22 May 2020

SYDNEY METRO REVIEW OF ENVIRONMENTAL FACTORS BAYS ROAD RELOCATION WORKS

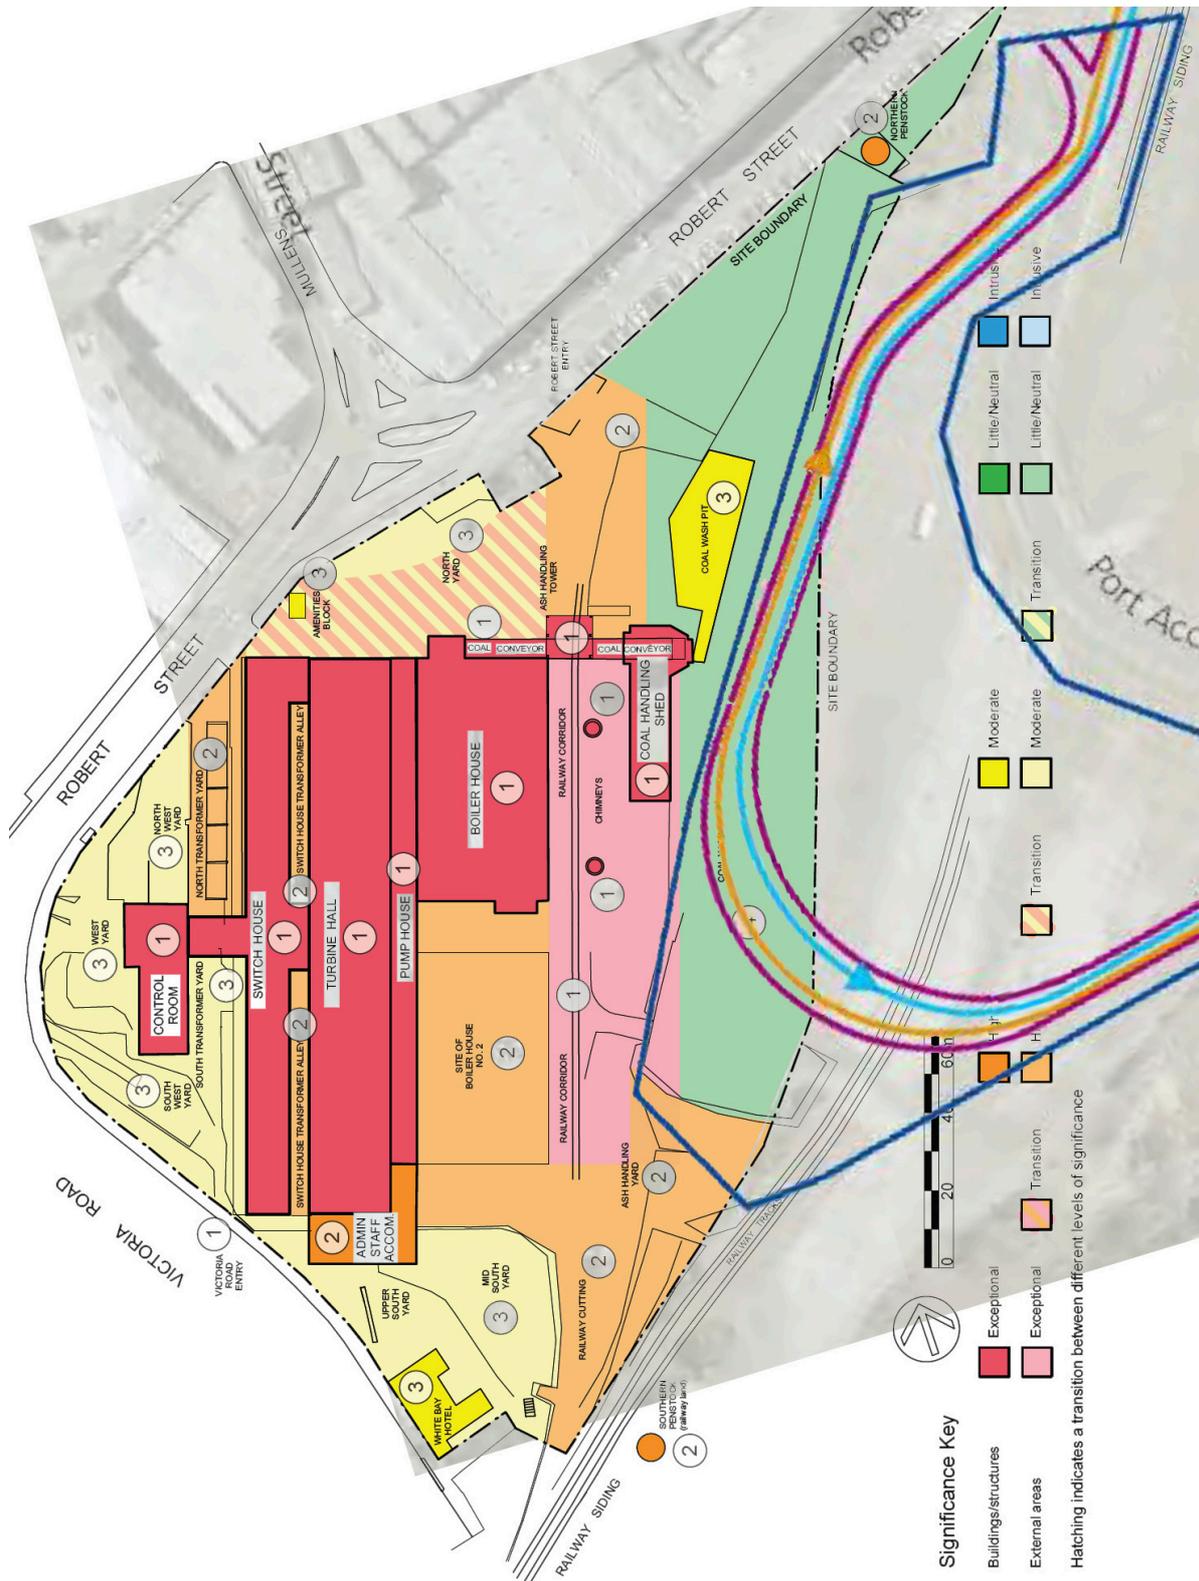
Summary	Comment
	<p>Policy 1.2.1 <i>Any development being proposed in the vicinity of the White Bay Power Station must carefully consider its bulk, scale and placement in order to respect the visibility and prominence of the power station as a harbourside landmark.</i></p> <p>Comment: We are satisfied and agree with the response in Artefact report on page 33 including their conclusion that “these changes have been considered minor due to the scale of the proposed works and the maintenance of views and vistas to and from the heritage item.” (Artefact; Statement of Heritage Impact, page 33). However, we reserve final comment subject to detail design.</p> <p>Policy 1.4.1 Spaces/elements graded 4 Little/neutral <i>These spaces, structures or elements retain only minor or neutral significance and may be retained or adapted substantially. Elements or fabric of higher significance should be retained if possible. Adaptation is preferred to complete removal. Walls and other elements shared between these spaces and other spaces of higher significance should be treated in accordance with the higher ranking as it affects that higher ranked space.</i></p> <p>Comment: While this is a fairly low significance area of the site, it is adjacent to sensitive structures. The main concern in this area is proximity of the proposed road to the Coal Handling Shed, the two extant steel chimneys and the guy ropes supporting the two chimneys.</p>

Figure 3.1: Design 5 overlay of *Figure 4-2 "Overview of the proposal"* from the *Review of Environmental Factors* (page 22) with *Figure 3.8.2.1 Site Plan Significance Gradings* in the *White Bay Power Station Conservation Management Plan* (page 88). The overlay shows the proposal of the Bays Road to be located predominately east of the Coal Handling Shed and within an area graded as having Little/Neutral significance (shown green). The road will be located close to the railway corridor which formerly serviced the Coal Handling Shed (accessed from the former Rozelle Railyards through the Victoria Road Bridge), and includes the former rail corridor and retaining wall and indicated as having Exceptional Significance.
